Service Bulletin No: 28-002**Ref No:** 44**Modification No:** EC-19-0081, EC-19-0191**ATA Chapter:** 28**FUEL - DISTRIBUTION
REPLACEMENT OF THE SADDLE CLAMPS AND ALIGNMENT OF THE MOTIVE-FLOW FUEL PIPES****1. Planning information****A. Effectivity**

PC-24 aircraft MSN 101 thru MSN 150.

Replacement of the saddle clamps and alignment of the motive-flow fuel pipes
Figure 1 (Sheet 1 of 3)

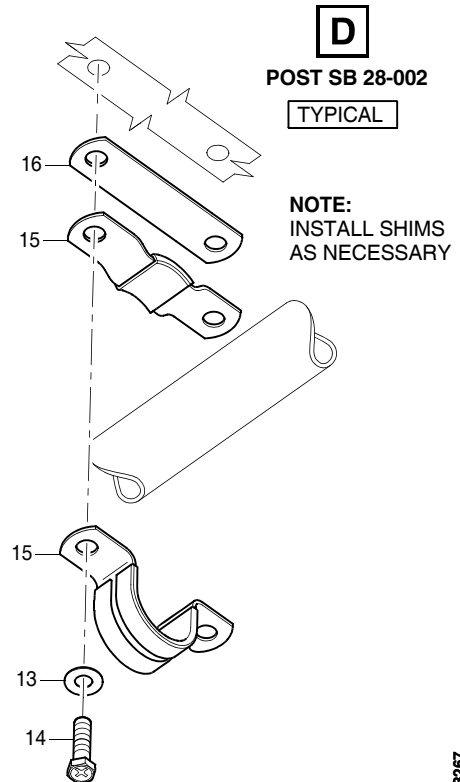
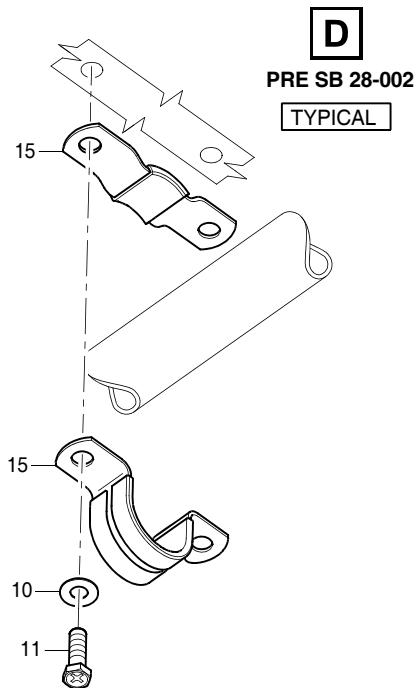
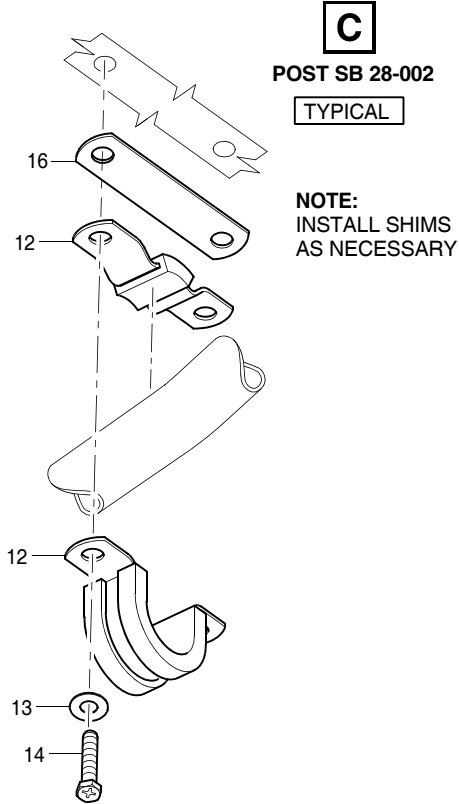
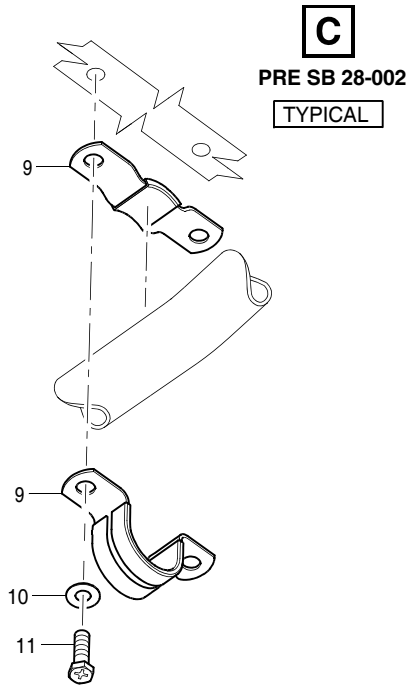
B. Modification
(1) Disassemble the slider shroud and coupling on the LH and RH motive-flow fuel pipe. Refer to Figure 1 (Sheet 1, View B)

- (a) Put a container below the LH and RH motive-flow fuel pipe at the slider shroud (8) and coupling (7) installation position.
- (b) Remove the slider shroud nut (1) from the slider shroud (8).
- (c) Move the slider shroud (8) onto the motive-flow fuel pipe sufficiently to get access to the two O-rings (4) that are installed on the two large ferrules (2).
- (d) Release and remove the coupling (7) from the motive-flow fuel pipe.
- (e) Move the sleeve (6) onto the motive-flow fuel pipe sufficiently to get access to the two O-rings (5) that are installed on the two small ferrules (3).
- (f) Remove and discard the:
 - Two O-rings (5) (P/N 946.91.30.015) that are installed on the two small ferrules (3)
 - Two O-rings (4) (P/N 946.91.30.218) that are installed on the two large ferrules (2).

(5) Assemble the slider shroud and coupling on the LH and RH motive-flow fuel pipe. Refer to Figure 1 (Sheet 1, View B)

- Two new O-rings (4) (P/N 946.91.30.218) on the two large ferrules (2)
- Two new O-rings (5) (P/N 946.91.30.015) on the two small ferrules (3).

- Outer surface only of the two new O-rings (3) that are installed on the two small ferrules (3)
- Outer surface only of the two new O-rings (4) that are installed on the two large ferrules (2)
- Inner surface of the sleeve (6)
- Inner surface of the slider shroud (8).

Replacement of the saddle clamps and alignment of the motive-flow fuel pipes
Figure 1 (Sheet 2 of 3)

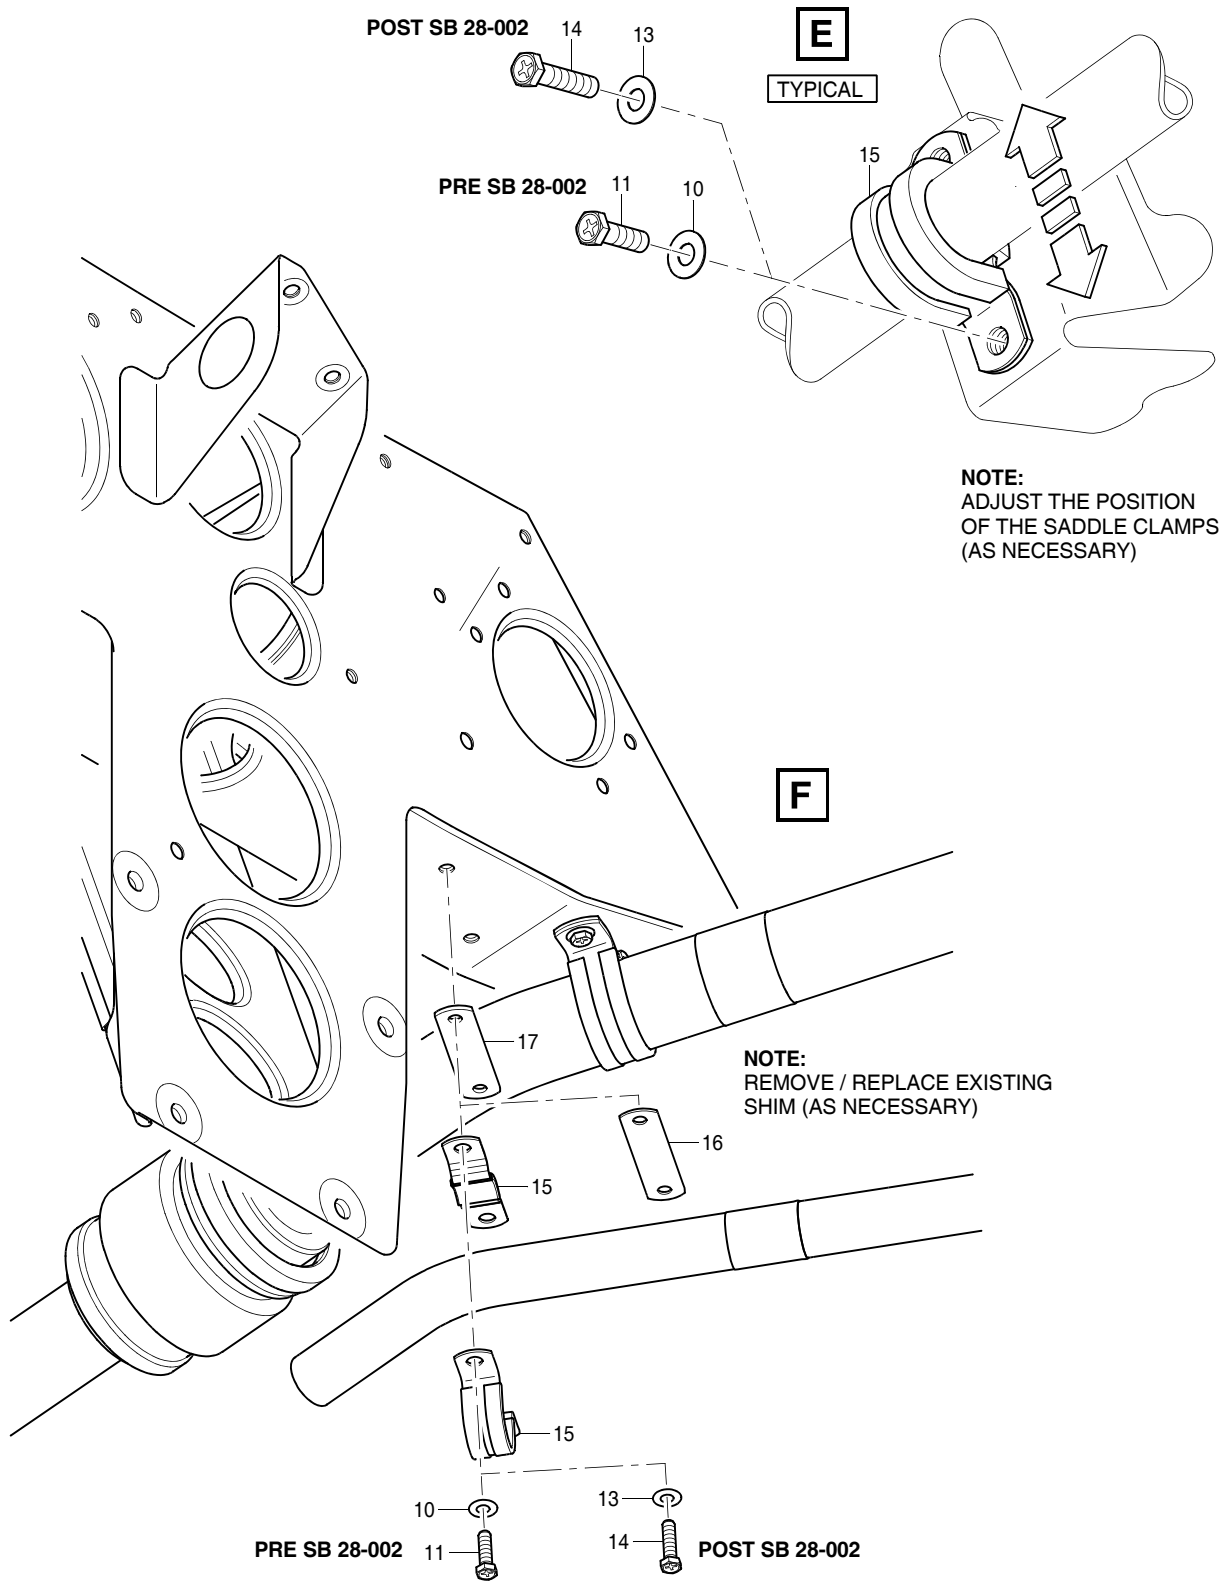
(2) Replace the saddle clamps on the LH and RH motive-flow fuel pipe. Refer to Figure 1 (Sheet 2, View C)

- (a) Hold the saddle clamp (9), remove the two screws (11) and the two washers (10).
- (b) Remove the two parts of the saddle clamp (9) from the structure and the motive-flow fuel pipe.

- (c) Discard the:
- Two parts of the saddle clamp (9) (P/N 946.33.22.004)
 - Two screws (11) (P/N 932.35.10.067 / P/N 932.35.10.069)
 - Two washers (10) (P/N 938.77.11.110).

- (d) If necessary, apply a thin layer of aeroshell grease 58 (Material No. P04-041) to the threads of two new screws (14) (P/N 932.35.10.070).
- (e) Put the two parts of the new saddle clamp (12) (P/N 946.33.21.933) in position on the structure and the motive-flow fuel pipe.

- (f) Loosely install two new washers (13) (P/N 938.78.11.202) and the two new screws (14) (P/N 932.35.10.070).
- (g) Do the above procedure again to replace the two saddle clamps (9) on the other motive-flow fuel pipe.

(3) Replace the screws and washers on the existing saddle clamps. Refer to Figure 1 (Sheet 2 and 3, View D, E and F)

(4) **Align the LH and RH motive-flow fuel pipes (as necessary). Refer to Figure 1 (Sheet 2 and 3, View C, D, E and F)**

NOTE: Due to the installation of the four new saddle clamps (P/N 946.33.21.933), the position of the LH and RH motive-flow fuel pipes has moved by approximately 0.06 in (1,5 mm). It is possible that it will be necessary to install (or remove) shims and/or adjust the position of the existing saddle clamps to correctly align the LH and RH motive-flow fuel pipes.

NOTE: This alignment procedure is very important. The permitted offset limits for the alignment of the LH and RH motive-flow fuel pipes are as follows:

- Axial offset must be between 0.12 and 0.16 in (3,00 and 4,00 mm)
- Radial offset must be a maximum of 0.02 in (0,50 mm).

Replacement of the saddle clamps and alignment of the motive-flow fuel pipes
Figure 1 (Sheet 3 of 3)

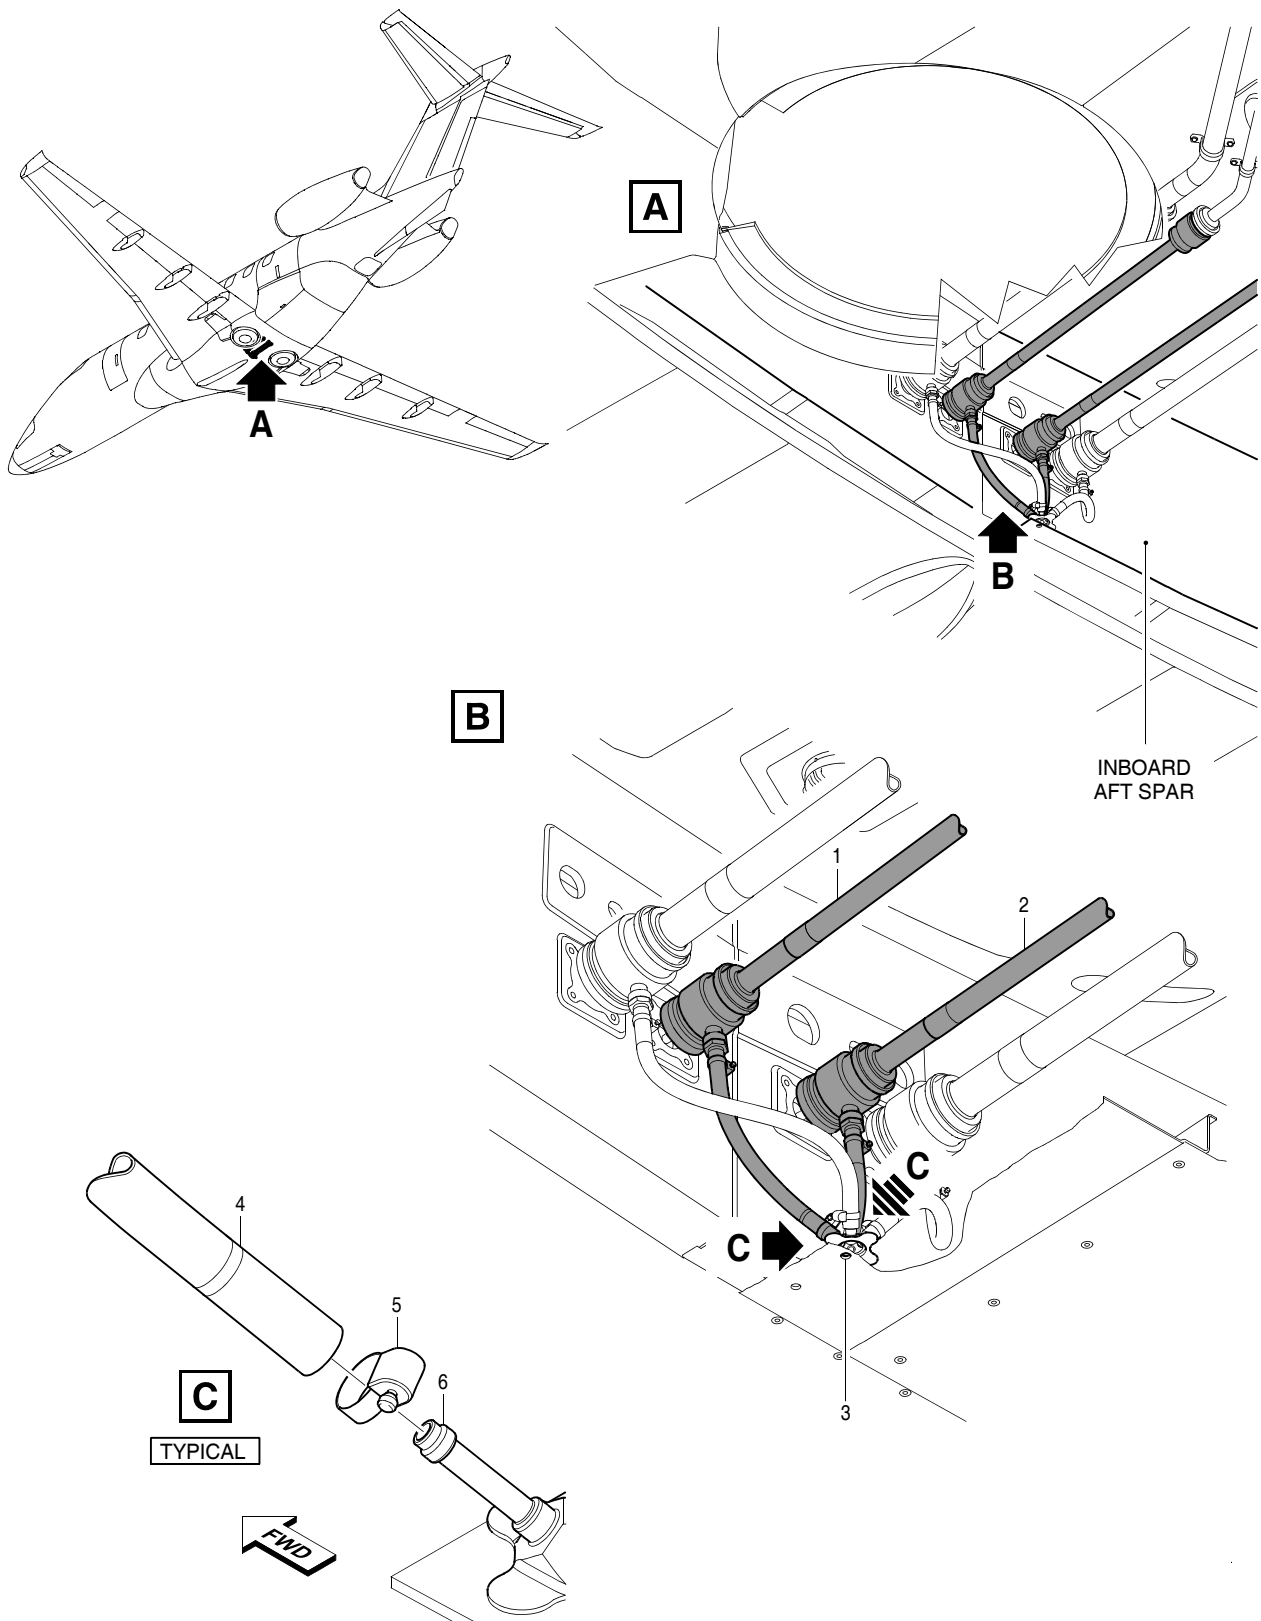
NOTE: The saddle clamp shown in View F already has a shim installed. It is possible that it will be necessary to remove or replace this shim.

- Install shims (16) at the saddle clamps (12) as shown in View C
- Adjust the position of the saddle clamps (15) as shown in View E
- Remove or replace the shim (17) as shown in View F.

9 If necessary, to adjust the position of the saddle clamps (15) as shown in View E:

ii Move the saddle clamp (15) up or down (as necessary) to correctly align the RH motive-flow fuel pipe. If necessary, adjust the position of the bracket that the saddle clamp is attached to.

- 10 If necessary, to remove or replace the shim (17) as shown in View F:
- i Hold the saddle clamp (15), remove the two screws (14) and the two washers (13).

- NOTE:** If necessary, a maximum of two shims can be installed below the saddle clamp.
- ii Remove the existing shim (17) or replace the existing shim (17) with one or two new shims (16) (P/N 528.22.24.105), as necessary, below the saddle clamp (15).
